Technical Service Information

MERCEDES 722.6 **K3 HUB AND REAR SUN GEAR ASSEMBLY DIFFICULTIES**

Figure 1

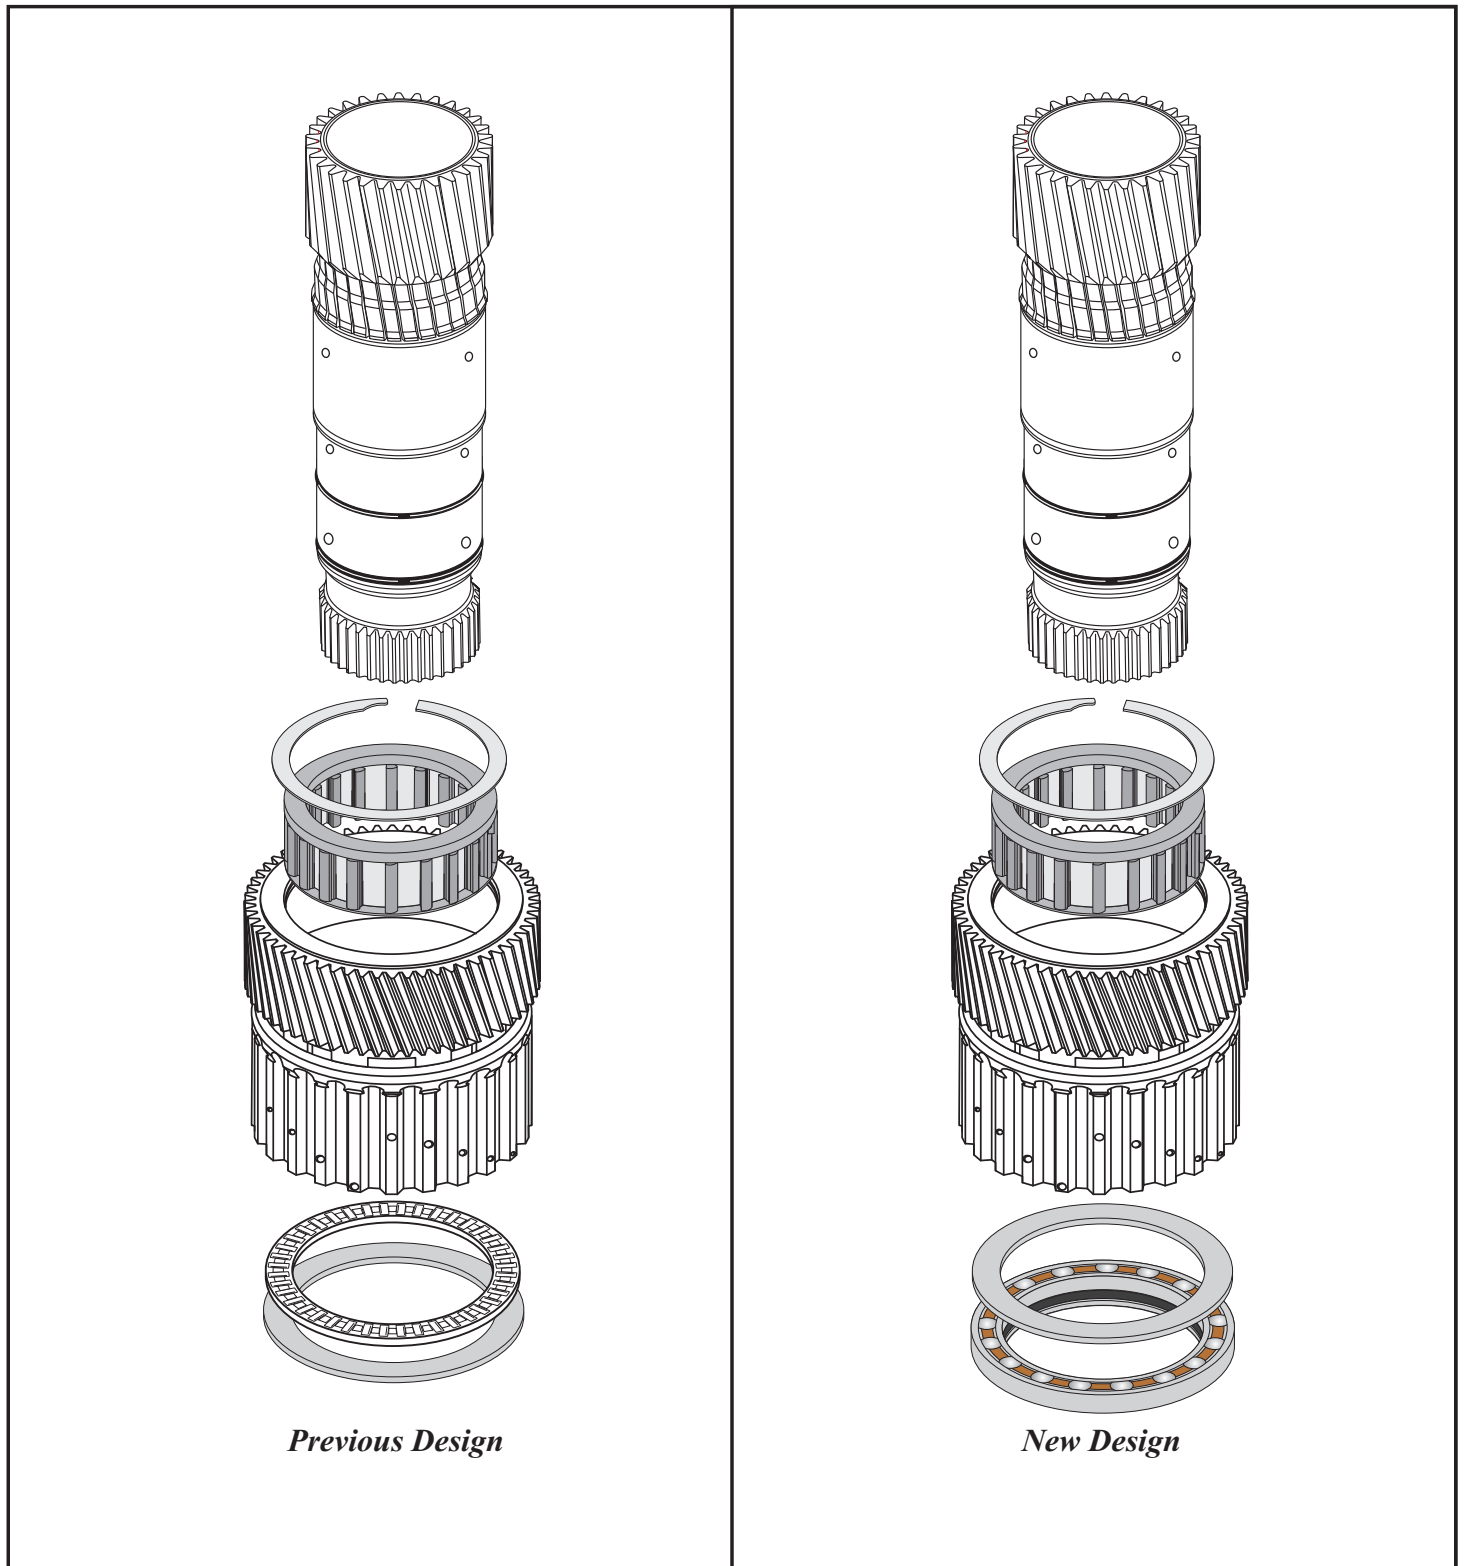
CAUSE: The new design K3 Clutch Hub and Rear Sun Gear have a flat spacer and ball bearing pressed into the hub assembly which replaces the previous design open face needle bearing and washer design (See Figure 1). In many cases, a brand new K3 clutch hub did not have the bearing fully pressed into the hub up against that flat spacer. This prevents the hub from being positioned correctly causing the insufficient clearance for the final retaining snap ring (Figure 2).

CORRECTION: Fully seat the bearing into the K3 Hub Assembly.
